23-29 CONGRESS STREET

APPLICATION FOR PERMIT

Re: 25 Congress Street

SITE PLAN / PLAN FOR
PROPOSED DECK @
25 CONGRESS ST.
FOR NANCE MORGAN

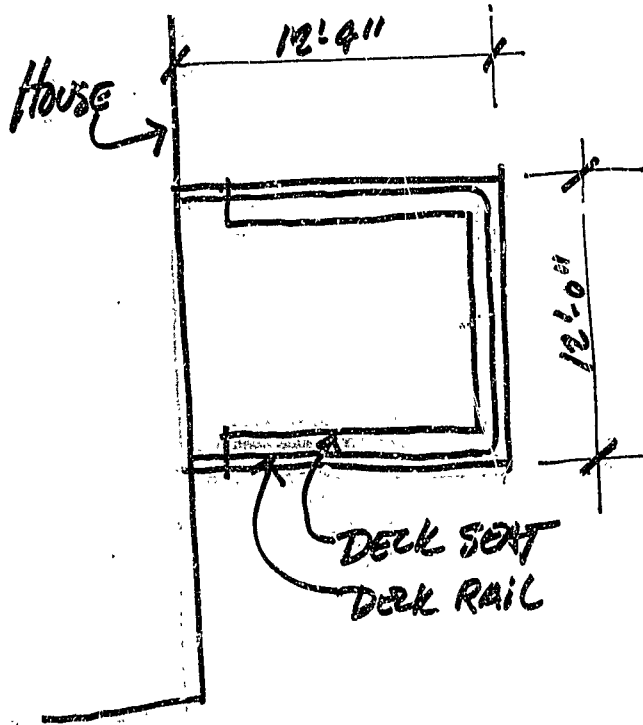
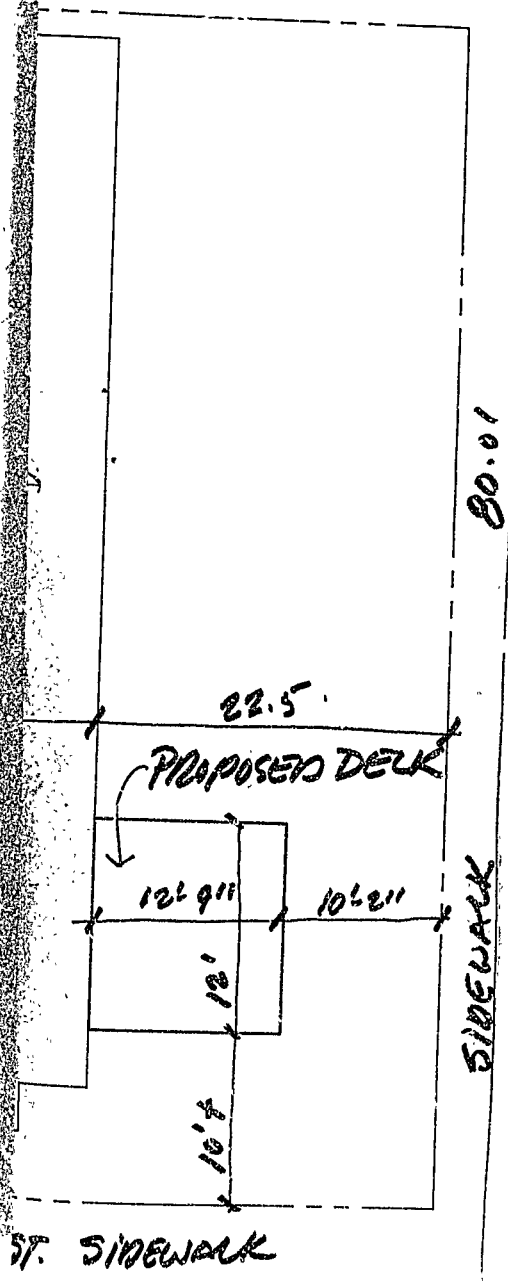
STAIR CONSTRUCTION minimum 9" tread
maximum 8 1/4" rise
